TOWN OF WESTWOOD
COMMONWEALTH OF MASSACHUSETTS

Re: Request of Superseding Order
DEP #338-706
Joanne Delapa, Applicant
14 Mill Street, Westwood

SUBJECT: DEP 338-0303 – Review Lot 2B Mill Street
Plan: Proposed Site Plan of Land, Lot 2B Mill Street in Westwood, MA:
Dated: March 9, 2001

Figure 6

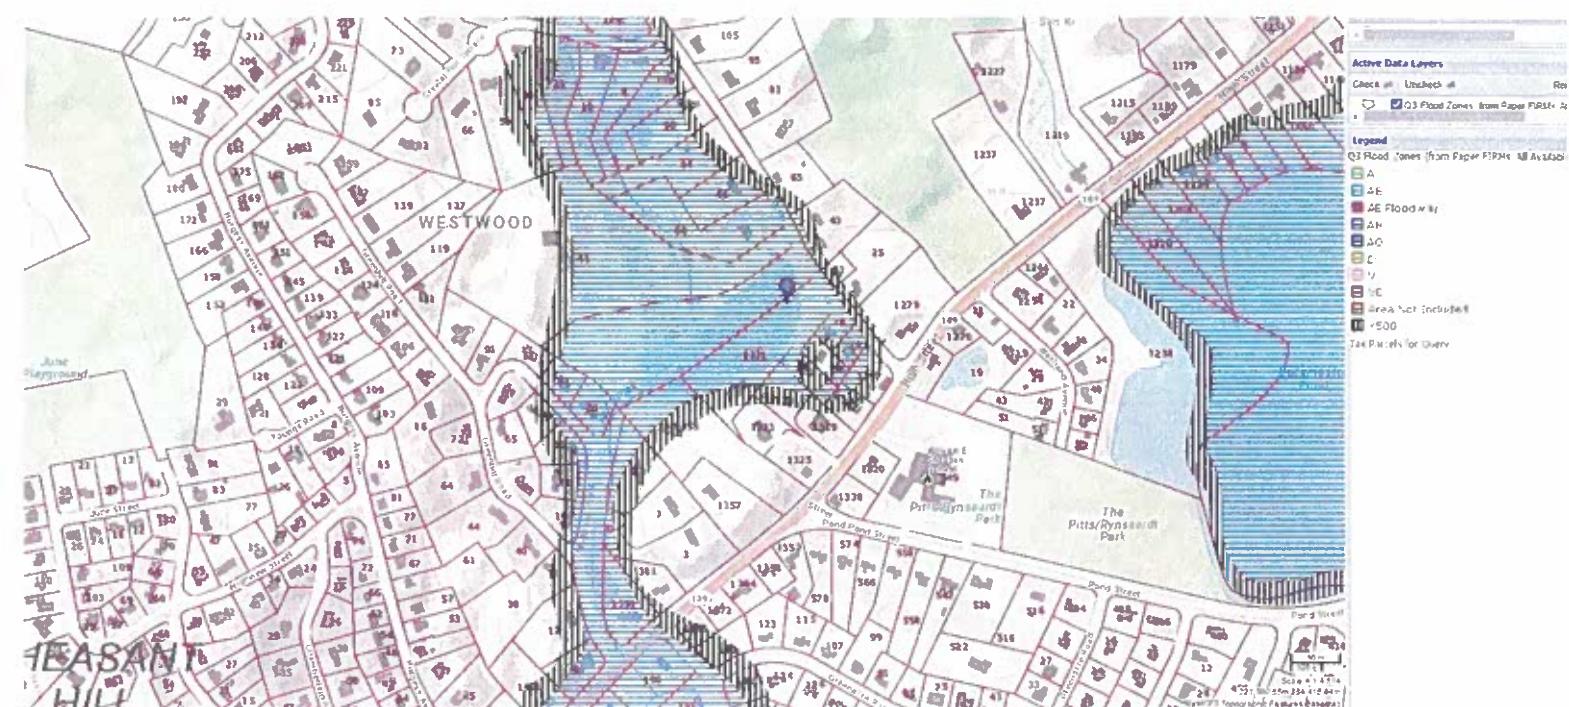
Attachment A is Figure 6 from the original report in January 2016 show the Brook following a channel for more than 140 feet south into the area of the 'pond' and therefore extends the bank of the perennial stream for that distance. The corresponding river front setbacks will also change due to that condition. The second attachment, B, shows the concrete dam and the dry stream channel in October 2020. Debris of the beaver dam can be seen upstream of the concrete dam. Also note the stream channel in the foreground is approximately 35-40 feet wide. The bank of this channel seems to be shown on the submitted plan following contour 184 whereas the channel that was measured is only 5 feet wide. (See Attachment I) This changes the riverfront setback by about 25 feet closer to the proposed house. The third attachment, C, shows the channel flowing at the same time the concrete dam was dry indicating that it now is the likely perennial stream due to the beaver dam. These two photos were taken during an official drought monitoring period. (see attachment G) The fourth photo D, shows the same channel on December 2 2020 after a 2.5 inch rain fall event from December 1. The fifth picture E, shows the same channel looking downstream. Based on this picture the level of the water at the main channel is approximately elevation 188 using the plan of record. This further expands the point of the perennial stream edge, 25 +/- feet closer to the project site because the edge if the perennial stream is the annual high water mark per the regulations. We continue to maintain as well that this stream is the perennial stream due to the changed condition of the beaver dam and the resulting pathway for the water is this channel as documented here. See attachment J. Furthermore based on this information the Commission has the right to consider the pond to not exist if it is not named on the USGS plan and if the characteristic of the steam can be documented through the impoundment. Attachment F is the latest FEMA flood map for the 100- and 500- year elevations from the MASS GIS system. Note that the entire site is within the 100 year flood plain including the house location. In fact the entire lot as shown is within the 100 year flood plain.

- A. Figure 6 from original report – indicating the stream channel flows approximately 140 feet through a vegetated wetland before entering the ‘pond’.
